UNITED STATES PATENT AND TRADEMARK OFFICE

APPLICATION NO.	FILING DATE	FIRST NAMED INVENTOR	ATTORNEY DOCKET NO.	CONFIRMATION NO.
10/801,554	03/17/2004	Kazuaki Shingo	10517/220	3477
23838	7590	06/05/2007		
KENYON & KENYON LLP 1500 K STREET N.W. SUITE 700 WASHINGTON, DC 20005			EXAMINER PHAN, HAU VAN	
			ART UNIT 3618	PAPER NUMBER
			MAIL DATE 06/05/2007	DELIVERY MODE PAPER

Office Action Summary	Application No. 10/801,554	Applicant(s) SHINGO ET AL.	
	Examiner Hau V Phan	Art Unit 3618

DETAILED ACTION

FIG. 3

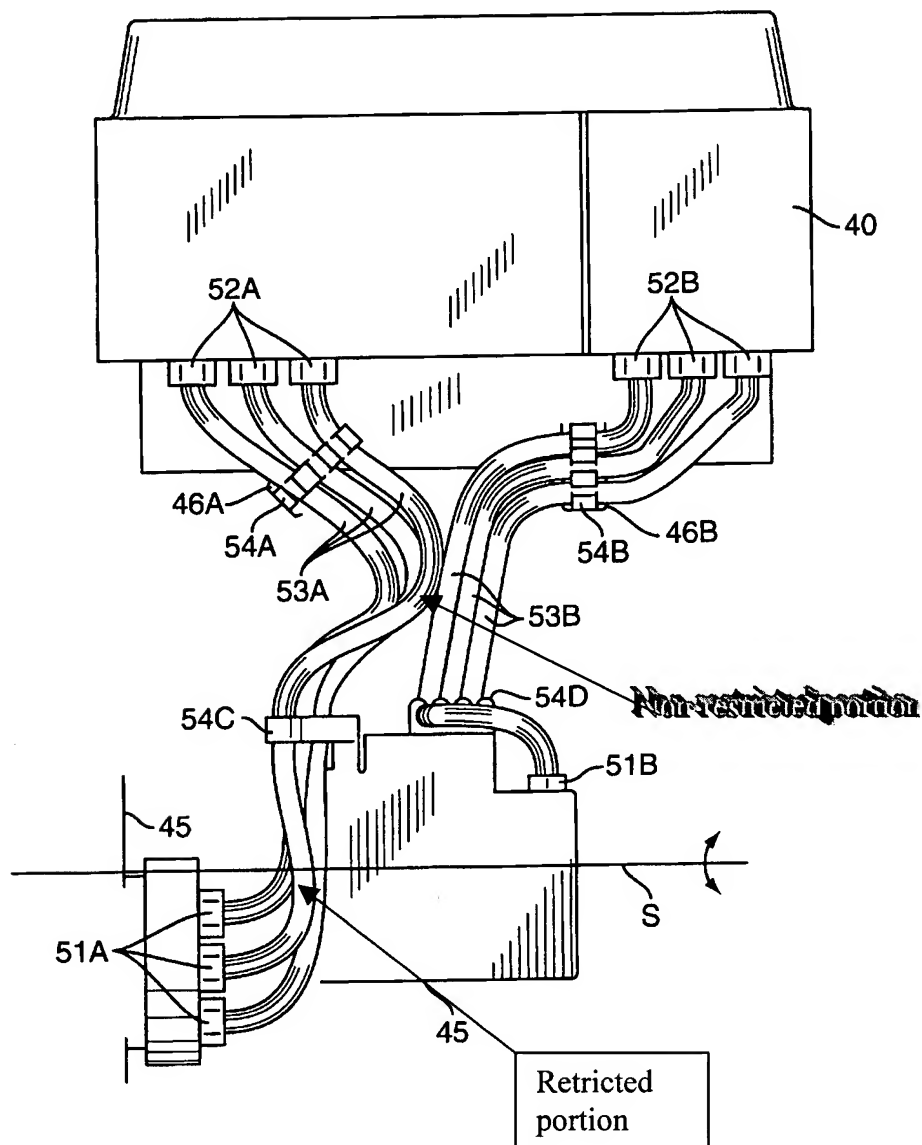
Hirano in figure 3, teaches a high power cable aligning device for electric vehicle comprising a securing unit (46A), which is used to secure the cable in place. The securing unit can be positioned at any location along the length of the cable configuration. It would have been obvious to one of ordinary skill in the art at the time the invention was made to modify the hybrid vehicle of Kashiwase et al. with the high cable aligning device having a securing unit as taught by Hirano in order to keep a safe distance for the wires from the hot components.

5. Applicant's arguments filed 4/26/2007 have been fully considered but they are not persuasive. In response to the applicant's remark that Hirano discloses the use of bracket and holders to secure cables to an inverter housing, as result, the restriction portion of the cable is positioned at the inverter. The examiner disagrees, because claim 15 recites, "the restricted portion thereof is positioned closer to the engine and the non-restricted portion is positioned closer to the inverter side. Hirano in figure 3, (below) discloses the non-restricted portion, which is the curve portion and positioned between the bracket (54C) and the inverter housing (40). Hirano also discloses the restriction portion, which is position between the bracket (54C) and the engine.
